**UPPER MISSISSIPPI RIVER SYSTEM
ENVIRONMENTAL MANAGEMENT PROGRAM**

**DEFINITE PROJECT REPORT/ENVIRONMENTAL
ASSESSMENT (SP-8)**

INDIAN SLOUGH

SUPPLEMENTAL REPORT FOR THE
INDIAN SLOUGH
HABITAT REHABILITATION AND ENHANCEMENT PROJECT
BUFFALO COUNTY, WISCONSIN

Figure 1

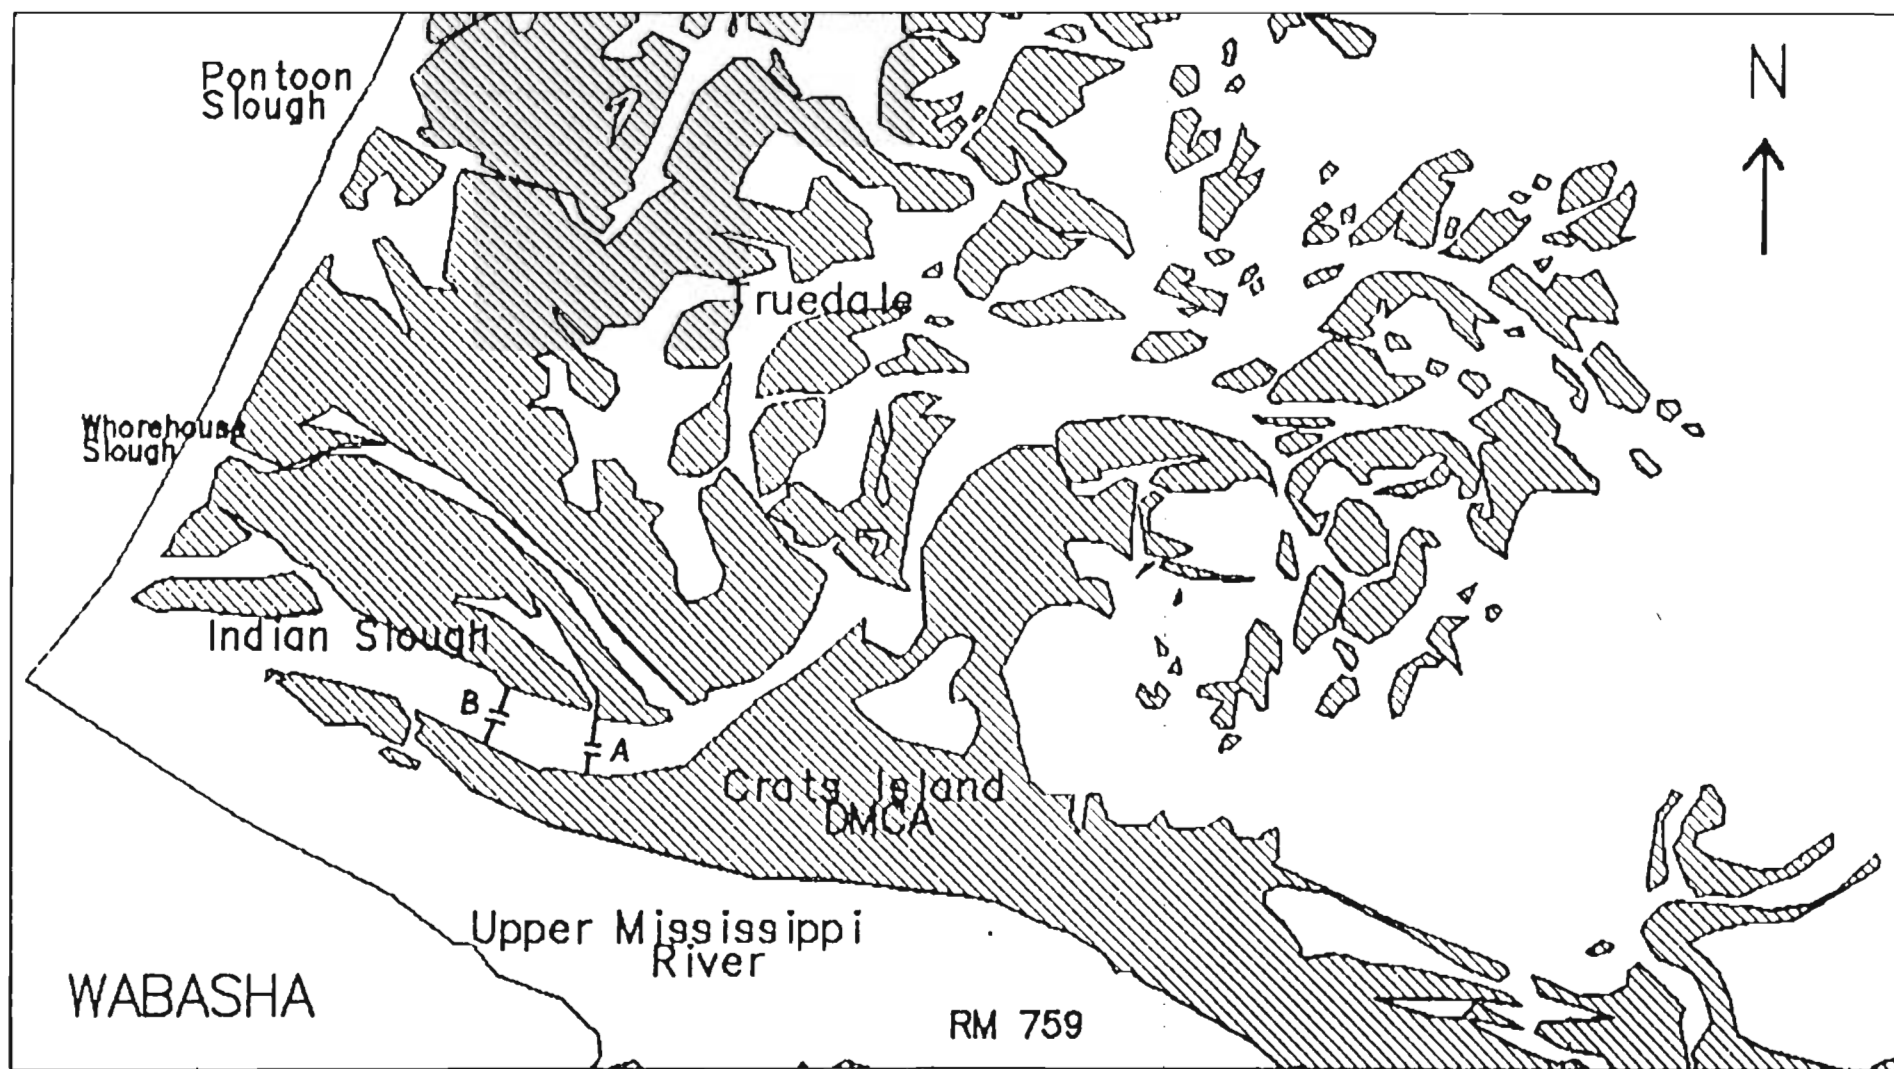
Design Modification - Since submission of the DPR, a design modification has been made to the "B" options. By shifting the location of this structure 600 feet upstream (figure 1), the amount of rock necessary for the structure can be reduced from 9,200 cubic yards to 6,200 cubic yards, and the need for bank stabilization adjacent to the structure can be eliminated. This reduces the cost of the "B" options by approximately \$140,400. This modification was identified during the early stages of plans and specifications when detailed surveys became available, and is being presented at this time because it offers a substantial cost savings over the design recommended in the DPR.

- A** - Location of structure B1 as proposed in the DPR (Sept. 1990)
B - Location of structure B1 as currently proposed (Nov. 1991)
